Final Immediate Response Action Plan, Building 3 Area Asbestos

Former Varian Facility Site, 150 Sohier Road, Beverly, Massachusetts 01915
MassDEP RTN: 3-38666

**NON-TRADITIONAL ASBESTOS ABATEMENT WORK PLAN
SOIL & CEMENT BOARD CLEANUP
150 SOHIER ROAD
BEVERLY, MASSACHUSETTS**

DRAWING TITLE
SITE PLAN

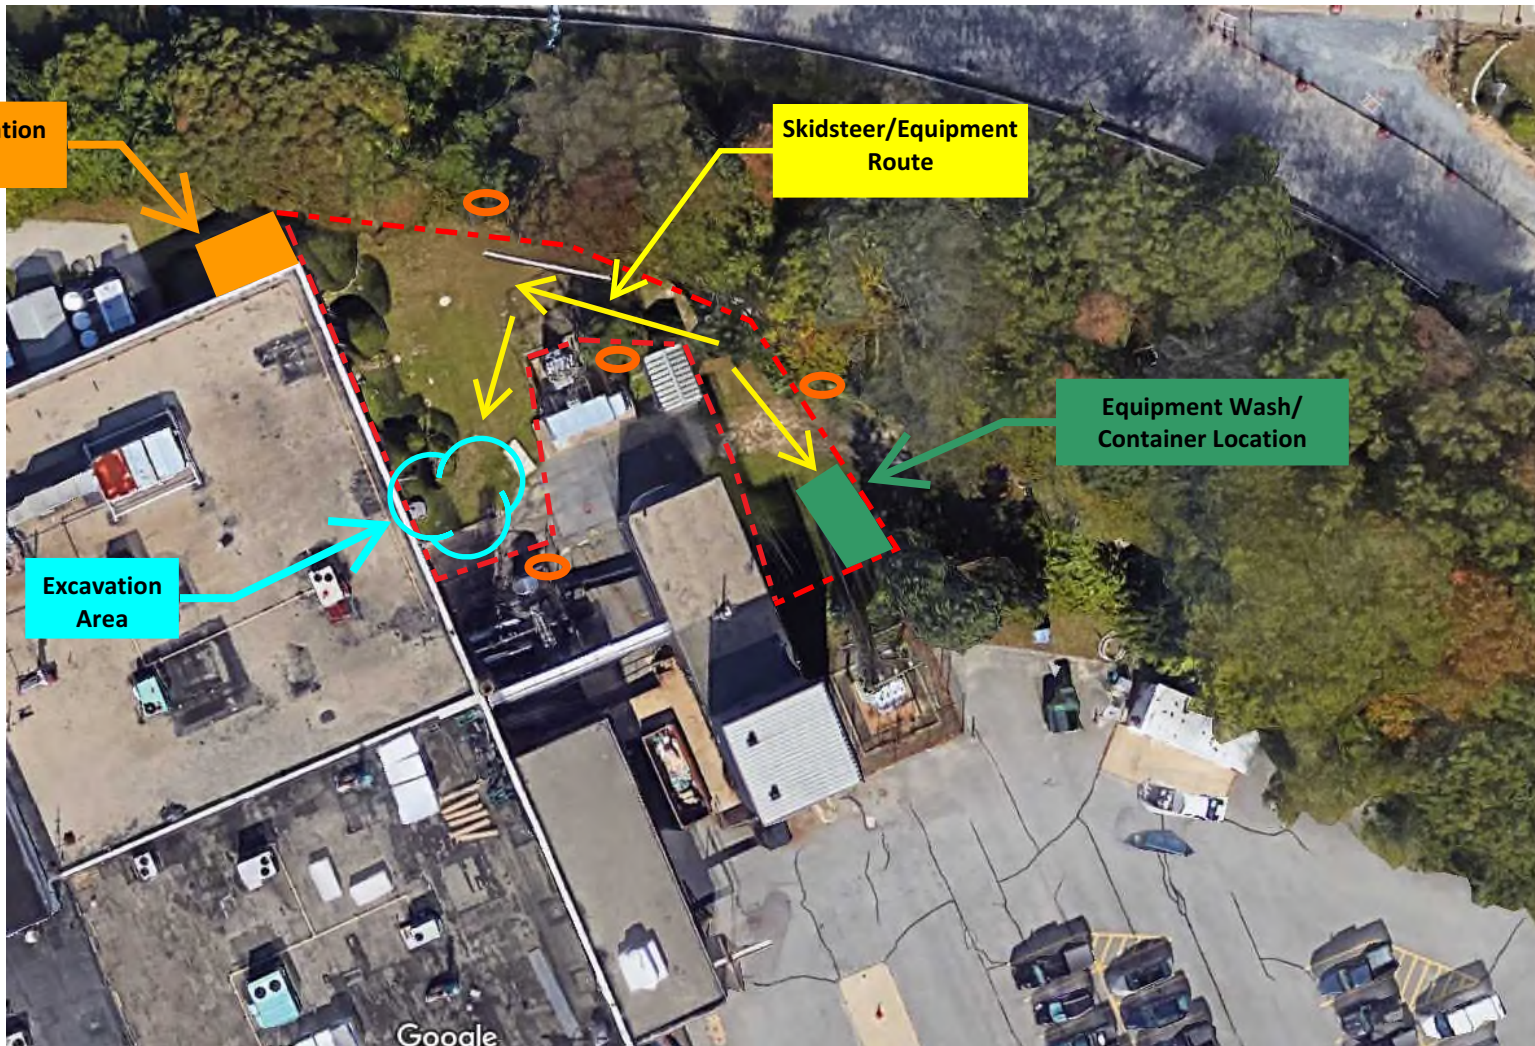
- Section 1 Bullet 5 - *The equipment route from the excavation area to the container/equipment wash will be covered with 10 mil rubber of sufficient width to prevent ACWM from contacting the ground.* At the end of abatement activities, please provide your proposal for handling the 10 ml rubber leading from the excavation area to the asbestos waste container. **Added to Section C3, #4 and #11**

store open top dumpsters at the Site you must indicate where will they be stored **Added to Section C3, #2**, how will they be secured overnight (preferably behind locked fencing), and what will be done to prevent water intrusion while awaiting transport, **Added to Section C3, #2**, how and add this area to your Site figure **edited**. We should discuss the proposed temporary onsite storage for 30 days as the integrity of the bladder seals may be compromised during such a lengthy storage. **Changed to 24 hours onsite.**

Section 3 Bullet 1 – Please provide your reasoning for using a skid steer to transport acwm from the excavation area rather than bulk loading directly from the excavator into the container. If this is your proposal, the path taken by the acwm-loaded skid steer must be addressed (e.g., covering, cleaning, etc). If possible, consider moving the truck wash/loading pad next to the excavation area.

- Section E Bullet 2 – Please add that DOT asbestos placards shall be applied to all 4 sides of the waste container. **EDITED**
- Please add the following text: **All components of the truck wash shall be disposed of as acwm in the last live load. EDITED to add truck wash in roll off container at the completion of work. Added to Section 3 #10**
- Site Figure – If possible, please move the truck wash closer to the excavation area. Please add the truck route. **EDITED The container and wash area cannot be placed adjacent to the excavation area due to building equipment obstructing access. Skid steer route to include rubber lining the route. Roll off container to remain in truck wash area.**
